FIELD INSPECTION

Project Name:	Mountain Valley Pipeline	Inspector:	Matthew Grant
Inspection Date:	Wednesday, July 24, 2019	Project Contact:	Brian Clauto
Spread: Montgomery Co. MP236 MN278.01 St12465+00	Spread H	Weather (Wet/Dry/Rain):	Wet

FIELD INSPECTION PHOTO LOG

- Fig. 1 AR MN-278.01 at designated stream S-EF54 crossing lacks protection at crossing.

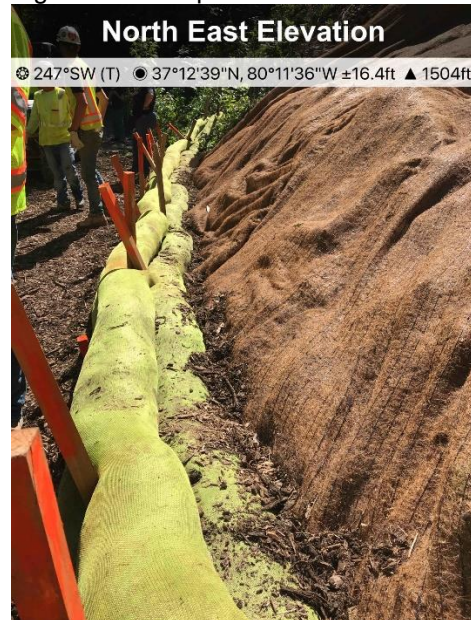
- Inspected designated streams and wetland included: S-EF54, S-EF20A, W-EF5-PFO
- Designated stream S-EF20A and wetland W-EF-PHO have been impacted by sediment, at the time of the inspection ECD's were in place and functioning.
- On access road AR MN-278.01 at designated stream S-EF54 crossing lacks protection at crossing. All other controls inspected that day were effective.

Recommended Corrective Action: Maintain and install all controls per the approved plan and specs, remove sediment per DEQ approval.

- Fig. 3. Sediment off ROW in designated stream EF-20A

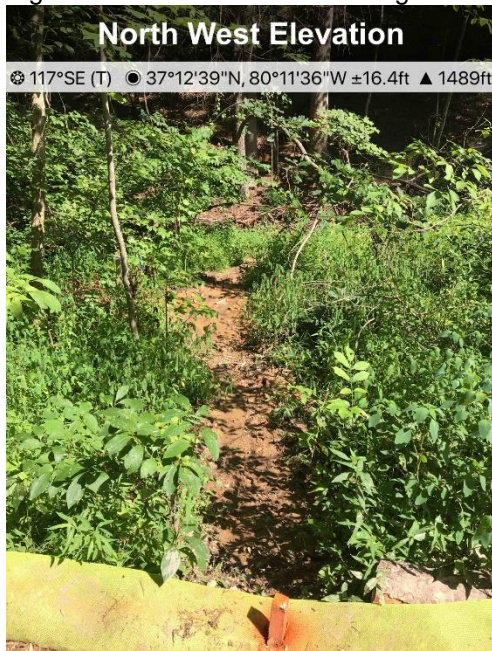
- Fig. 4. Sediment off ROW in designated wetland W-EF-PFO
